SPRAGUES PLACE PUBLIC HEARING CONTINUATION

In response to the comments by Azu Etoniru, Town Engineer (TE) in an email dated 11/30/17, Silva Engineering Associates (SEA) provides the following responses:

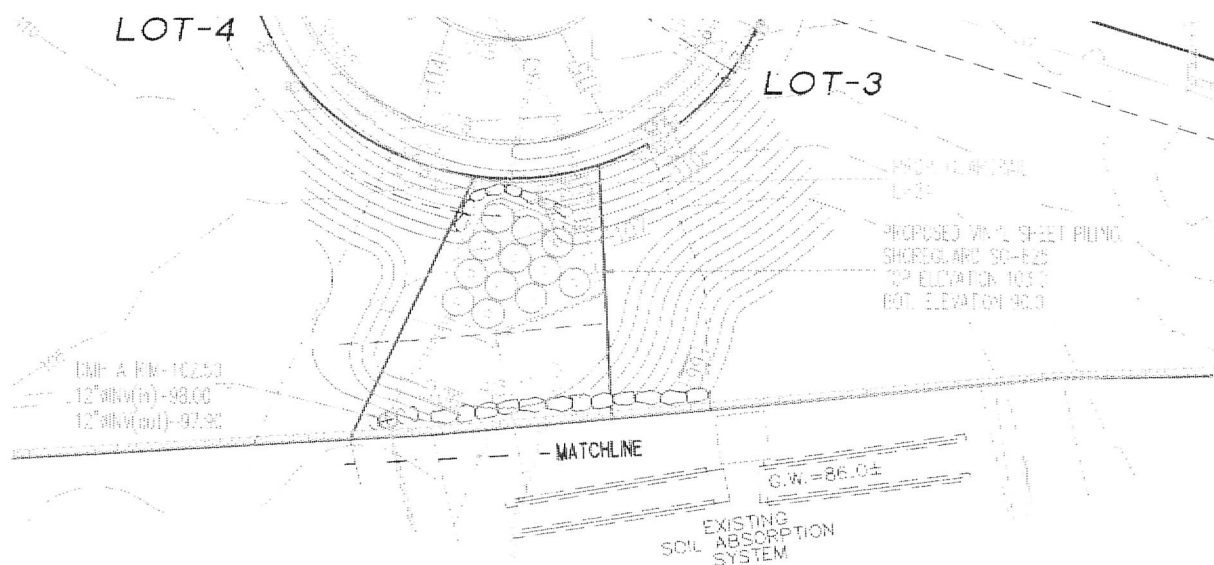
TE Comment 2: Section IV.C.2.c of the regs does not allow the centerline offsets of the intersections of residential streets with sub-collector streets to be less than 125 feet. The centerline offset between the intersection of Sea Tower Drive and Broad Street, and the intersection of Joanne's Way and Broad Street is approximately 77 feet, which is 48 feet less than the specified

minimum distance. The approach of Broad Street towards its intersection with Joanne's Way has a limited sight distance, and that could prove problematic and pose safety hazard to traffic entering and exiting Joanne's Way, especially in light of its proximity to the intersection of Sea Tower Drive with Broad Street. There wouldn't be sufficient reaction time for north bound traffic attempting a left turn exit from Sea Tower Drive and a south bound traffic attempting a left turn exit from Joanne's Way in concert with emerging south bound traffic on Broad Street traveling at speeds of 40 to 50 miles per hour.

SEA Response: The offset distances between the roadways is mitigated by the traffic controls at High Street and because the volume of traffic from both Sea Tower Drive and Sprague's Way is minimal. Sprague's Way has been in existence as a right of way since the two duplex units were constructed on Broad Street in 1988, long before Sea Tower Drive was constructed. Both of these duplexes have used the right of way for access during this 30 year period. The offset was certainly more of a concern prior to the installation of traffic lights.

The right of way was established on an Approval Not Required plan dated 9/15/1986¹, which clearly indicated that the 40-foot access was to be used for a "future road".

The offset issue is the result of the Sea Tower Drive² development (2004) and not of the current project. Regardless, I believe that the scenarios brought forth in the review comment are easily handled by responsible drivers entering an intersection. Use of turn signals and access at appropriate times of the light cycle seem sufficient to avoid a serious problem. Addition of a street sign to inform north bound traffic on Broad Street of the blind drive ahead could be beneficial.
